Phi Mu Sidewalk

Land Use and Facilities Planning Committee

LAND USE AND FACILITIES PLANNING COMMITTEE MINUTES

MP03994 – 416 – Phi Mu Sorority Addition

SIDEWALK SITE PLAN

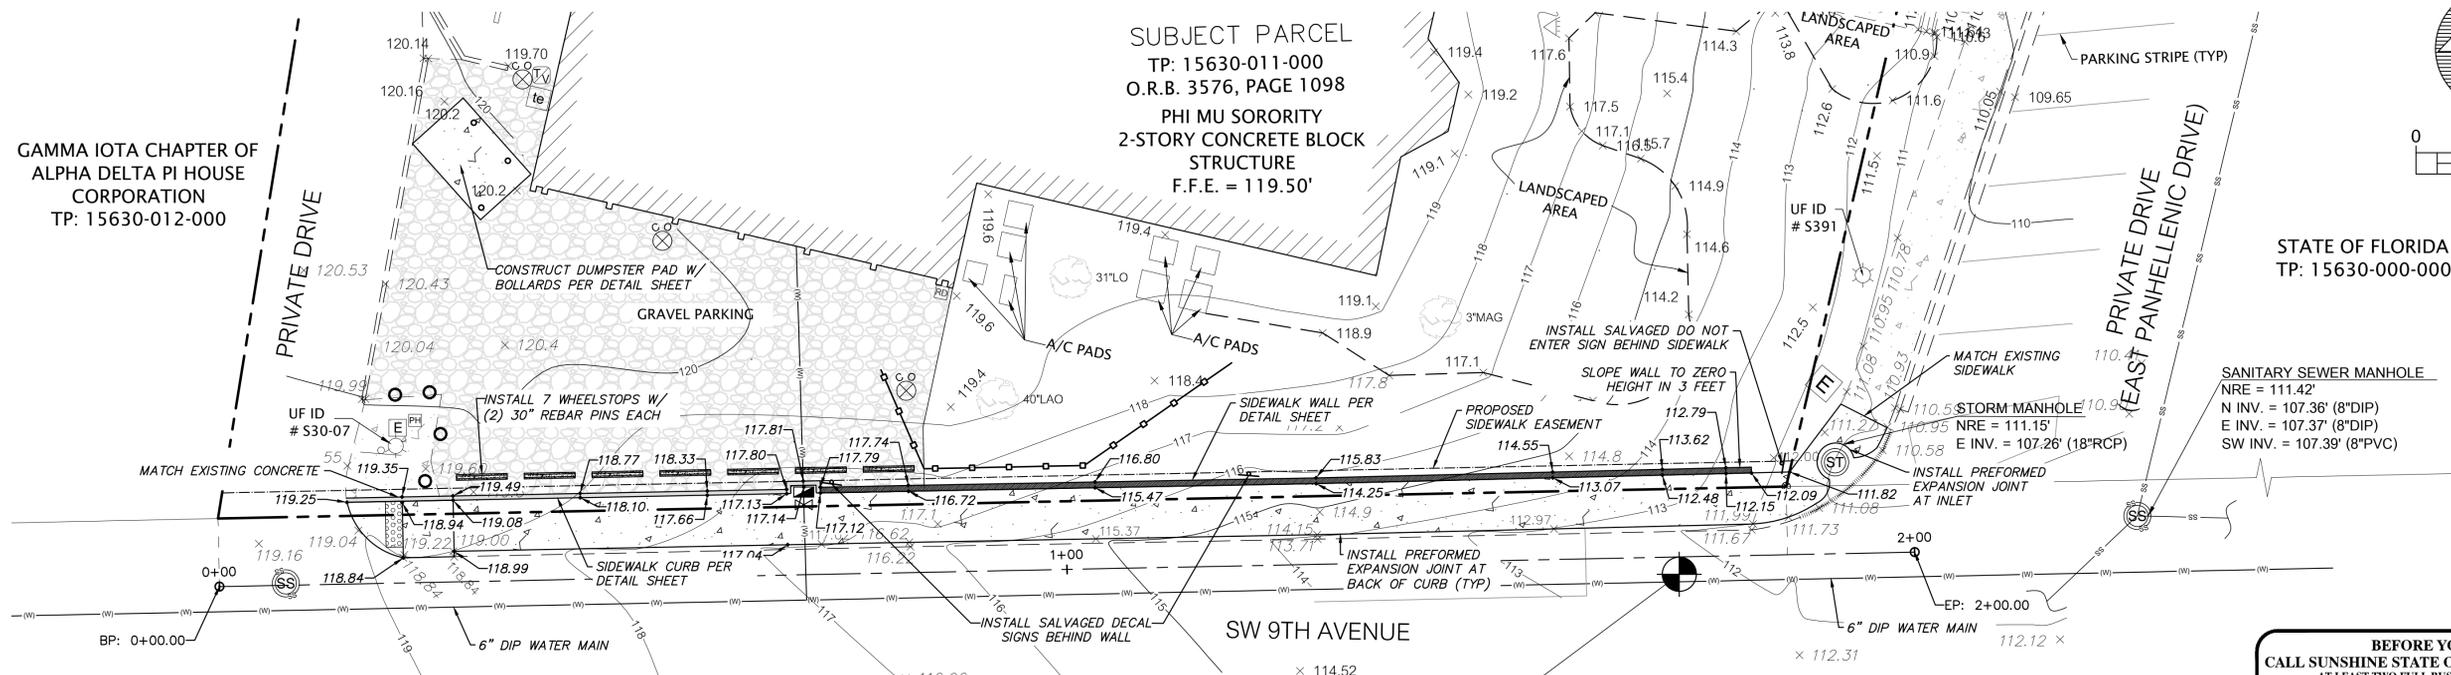
Fast forward to construction phase for sidewalk. Locates were called for and some exploratory excavation completed for the purpose of laying out the sidewalk and beginning site prep to install the sidewalk. It was discovered that the locations of the existing utilities were identified and a realization that they are in direct conflict with the sidewalk installation.

Here is a conceptual cost estimate for relocating the water main lower for placement of the sidewalk shown on the plans.

*Pipe Installation : \$17,500 (Includes cost of pipe, labor, and equipment for an estimated length of 160 lf)
MOT, Fill, Testing : \$8,000
Sub-Total : \$25,500
10% Contingency : \$2,550
Total : **\$28,050***

This assumes that curbing and asphalt will not need to be touched and that the relocation can occur within the currently grassed area.

*If the curbing and asphalt areas need to be impacted, then it would be roughly **\$5,000** for each end which would include the additional piping, labor, asphalt and curbing replacement.*

The owner's resources have been exhausted and BBI feels redesigning the sidewalk to go around the utilities along 9th is not feasible given the existing grade change. We've exhausted all other design options for 9th and moving utilities is our

only option if the sidewalk is to stay in the project. Phi Mu is scheduled to be complete in 4 weeks and this sidewalk was understood to be a requirement for CO. In light of our current situation, would it be possible to decouple the sidewalk from the CO requirement to allow time to resolve the conflict?

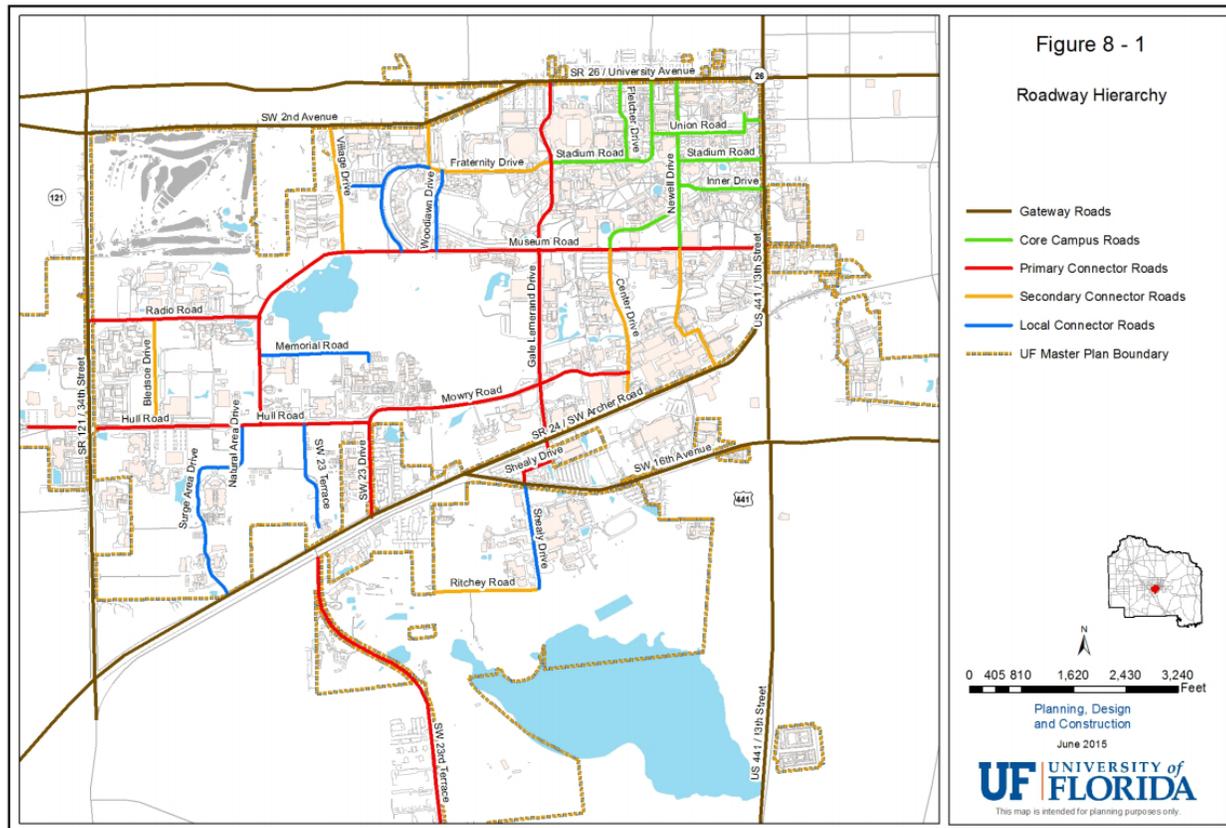
There are exceptions but none related to utility conflicts. Has anyone approached GRU on relocating them to have the appropriate cover requirements. If you can't fit a 4" thick sidewalk in, then there is no cover on the utility, which doesn't meet their or FDEP standards (assuming it's water or sewer).

The UF Masterplan doesn't really determine the roadway type. I would think that it would be similar to Fraternity Drive (which is a local connector road) but I could see where they could classify it as Secondary Connector Road.

The below image and text (below the image) is from the UF Masterplan (Chapter 8 Transportation Data & Analysis). Note a local connector road only requires a sidewalk on one side vs. a secondary connector road requires it on both sides. See below.

One thing to bring up, is Alpha Delta Pi Sorority only built a sidewalk to their screen wall (West of Phi Mu). Why should this project be required to connect to it when they didn't extend to the alley road?

Note the roadway slope is not a problem as the City will allow the contractor to use PROWAG standards, which allows the sidewalk to follow the roadway longitudinal slope.
